August 18, 2020

Subject: Response to EPD Engineering Revision Review Comment: Georgia Power Company Plant Hammond Ash Pond 3 (AP-3): Clarification of Assigned Groundwater Model Recharge Value

Figure 17: Model Recharge Zones

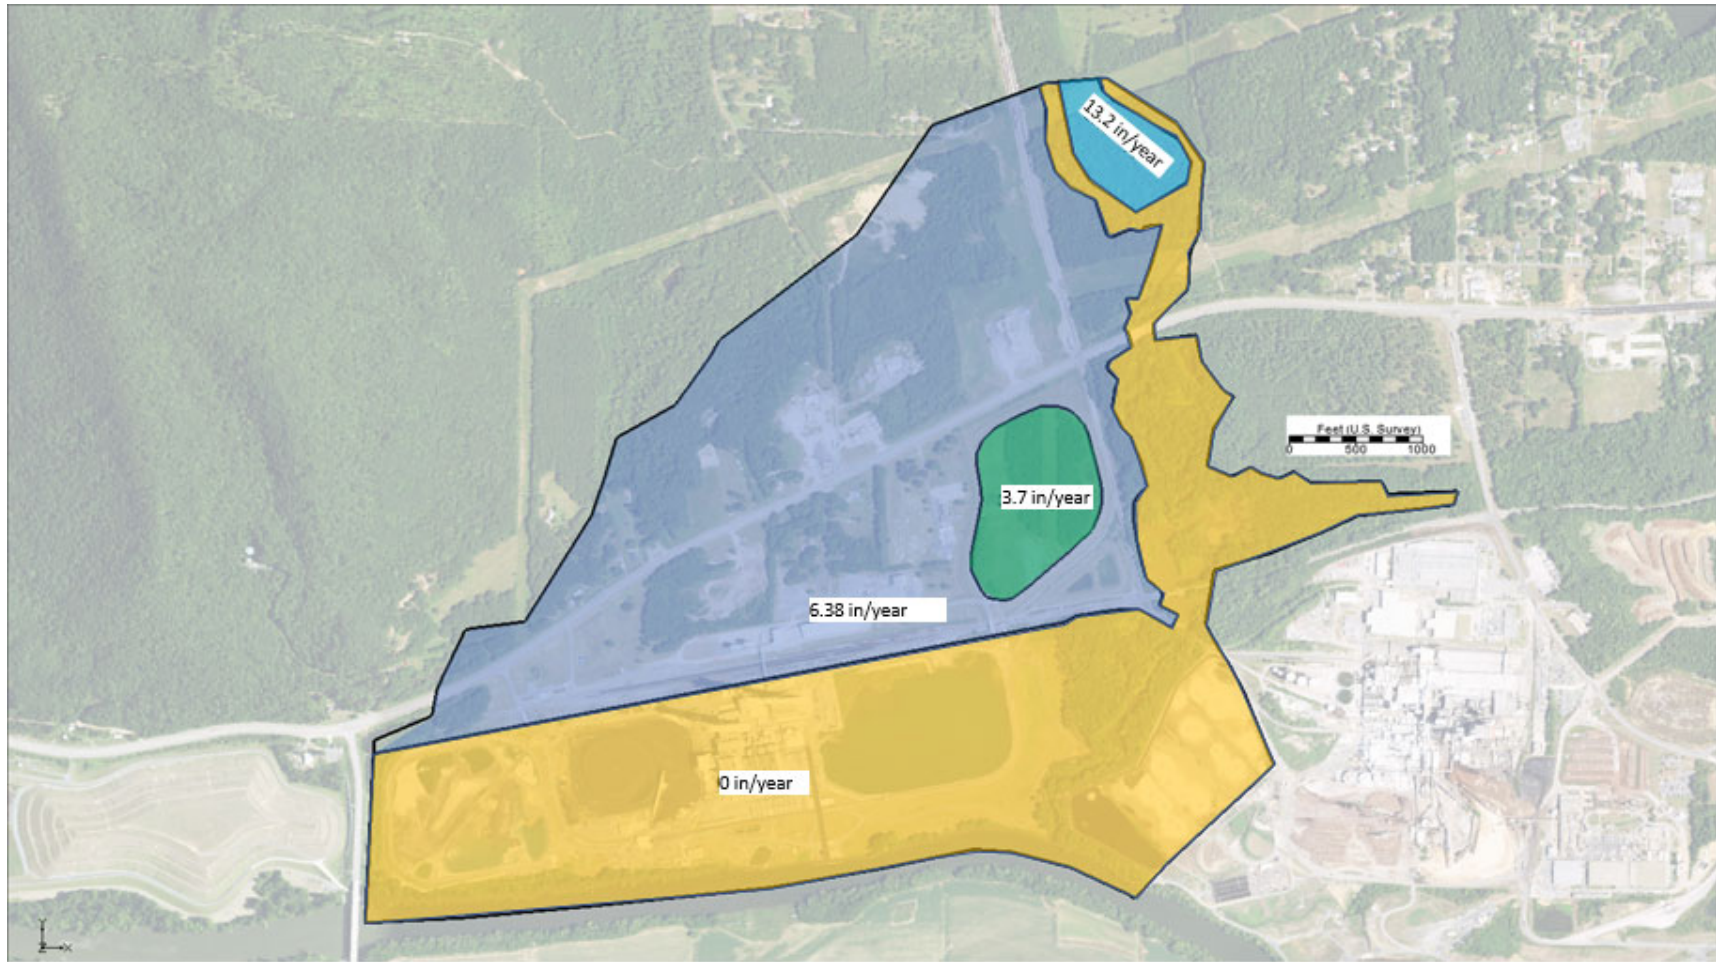
At the request of Georgia Power, EPD clarified that the variation noted in the comment above was a recharge value of 7.4 inches per year (in/yr) reported on page 6 and Figure 17 of the Groundwater Modeling Report, and that a value of 6.38 in/yr was used in the model input files. The discrepancy is due to a typographical error. The value of 6.38 in/yr is the correct value. Attached with this memorandum is a revised version of page 6 of the text and Figure 17.

The USGS performed a recharge study for the Coosa River basin (USGS, 1996). The study evaluated average recharge for the 4,040 square mile drainage basin that is represented by streamflow measurements made at a point on the Coosa River approximately 8 miles east of the Site. The recharge study estimated that the average recharge rate for the entire basin was 13.2 inches per year, but may be as low as 3.2 inches per year during droughts. It should be mentioned that these estimates are averages. Actual recharge will vary locally based on topography, surface water, run-off, man-made drainage features, rainfall intensity, etc. Therefore, these two recharge estimates were used as the upper and lower bounds for estimating recharge assigned to various zones within the model domain during model calibration. As shown in **Figure 17**, four recharge zones were assigned to the Site. The area south of the railroad tracks does not receive recharge as much of the area is covered with pavement or buildings and the remainder of the area is close to the Coosa River and is therefore in a discharge area. The area north of the railroad tracks was assigned a recharge value of 6.38 inches per year.

This reflects the lower amount of recharge expected in the area due to runoff from relatively steep topography and the presence of man-made stormwater ditches. The area north of Cabin Creek was assigned a recharge of 13.2 inches per year as it is the headwaters area for Cabin Creek. Additionally, AP-3 was assigned a recharge rate of 3.7 inches per year in stormwater runoff is directed to an inner perimeter stormwater collection system. This recharge rate depicts baseline conditions for when the AP-3 cover system was incomplete
